# UNITED STATES PATENT AND TRADEMARK OFFICE

10/528,342

### Office Action Summary

TOLLE ET AL.

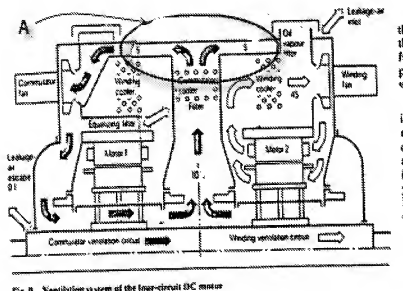
A redundant cooling device for an electric submarine drive motor, comprising (Fig 9 and page 100 Col 3 ll 4-8):

a first cooling circuit and a second cooling circuit, adapted to transport thermal energy away from the electric submarine drive motor, wherein coolant of the first cooling circuit and coolant of the second cooling circuit are adapted to flow in counter current (Fig 9) through a stator cooling ring of the electric submarine drive motor, in a region of the electric submarine drive motor (Fig 9 and Fig 9.A below and page 100 Col 1 ll 1-7).
